# UNITED STATES PATENT AND TRADEMARK OFFICE

10/531,104

<b>Office Action Summary</b>	<b>Application No.</b> 10/531,104	<b>Applicant(s)</b> LAIHO, KIMMO	
	<b>Examiner</b> Khanh Dang	<b>Art Unit</b> 2111

- 1) ☒ Responsive to communication(s) filed on 16 April 2009.
- 2a) ☒ This action is **FINAL**.                      2b) ☐ This action is non-final.
- 3) ☐ Since this application is in condition for allowance except for formal matters, prosecution as to the merits is closed in accordance with the practice under *Ex parte Quayle*, 1935 C.D. 11, 453 O.G. 213.

Fig. 3

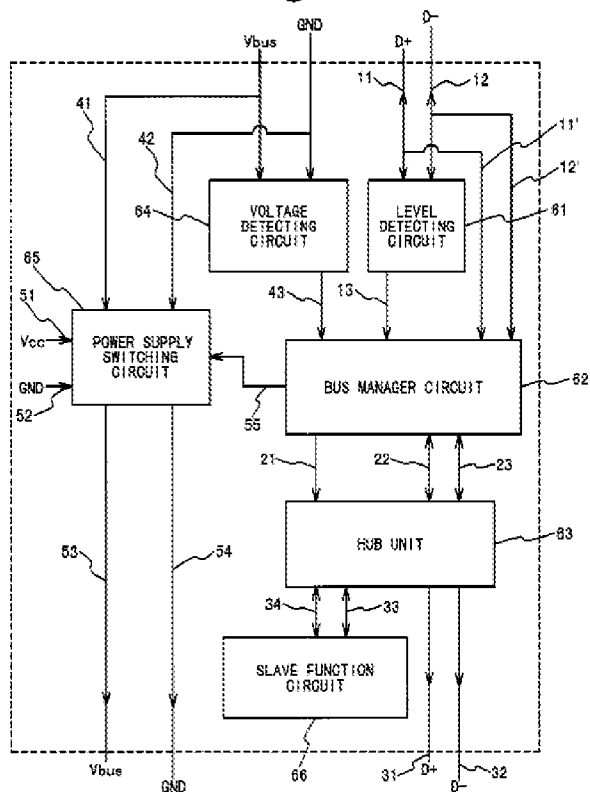
With regard to claim 1, Oguma discloses a device operable as a host device (as shown generally in Fig. 3, which is reproduced below for ease of convenience and reference, the portable device comprises a bus manager circuit can be operable as a host device)

comprising: a port connected to a bus (as shown in Fig. 3, USB port of the portable device provides connection to the USB bus comprising Vbus, GND), means for detecting the presence of another host connected to the bus and for relinquishing host status in response thereto (the voltage detecting circuit 64 is readable as the so-called “means for detecting.” When the detecting circuit 64 detects presence of another host 1 connected to the USB bus, the host status of the portable device is relinquished. See at least column 2, lines 39-57, column 4, line 65 to column 6, line 17).

With regard to claim 2, the host provides power supply for providing a supply voltage on a voltage supply line (Vbus GND) of the bus.

With regard to claim 4, it is clear from discussion above that the voltage detecting circuit detects a change in voltage on a voltage supply line of the bus, thereby detecting the presence of the other host. See at least column 2, lines 39-57, column 4, line 65 to column 6, line 17).

With regard to claim 7, as best the Examiner can ascertain from the language of the claim, in Oguma, the portable device is arranged for causing at least some lines Vbus GND, D lines of the port to be forced tri-state such as suspended, active, and unavailable states, on detecting the presence of another host.

**Figure 3**

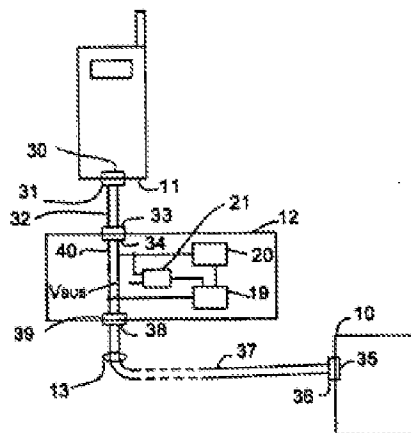
In response to Applicants' argument, at the outset, Applicants' Fig. 3 is reproduced below for comparison.

As shown in Applicants' Fig. 3, element 12 is the so-called "device operable as a host device," element 33 is the "first port," element 38 is the "second port," element 19 is the "host module," element 20 is a "comparator," and element 10 is the so-called "host externally connected to the bus."

Thus, contrary to Applicants' argument, Fig. 3 of Oguma, which is reproduced below for ease of reference and comparison, shows the so-called "device operable as a host." Further as shown in Fig. 3, the device includes a USB bus comprising Vbus,

GND, D+, and D-. The device further comprises a first upstream port connected directly to the USB bus; and a second downstream port connected directly to the same USB bus running from the first upstream USB port to the second downstream USB port. The device as shown in Fig. 3 of Oguma also shows the so-called "host module" or bus manager circuit 62 connected directly to the same USB bus; and the "comparator" or voltage circuit 64 detecting coupled to the same USB bus to detect the presence of a host externally connected to the USB bus. A voltage detecting circuit basically comprises a voltage comparator for comprising a supply voltage with a reference voltage (VREF) to detect a change in voltage or a difference between supply voltage and reference voltage. Further, as noted above, a USB bus comprises Vbus, GND, D+, and D-. It is also important to note that Applicants' Fig. 3 shows a Vbus line, and other lines are grouped together as line 40.
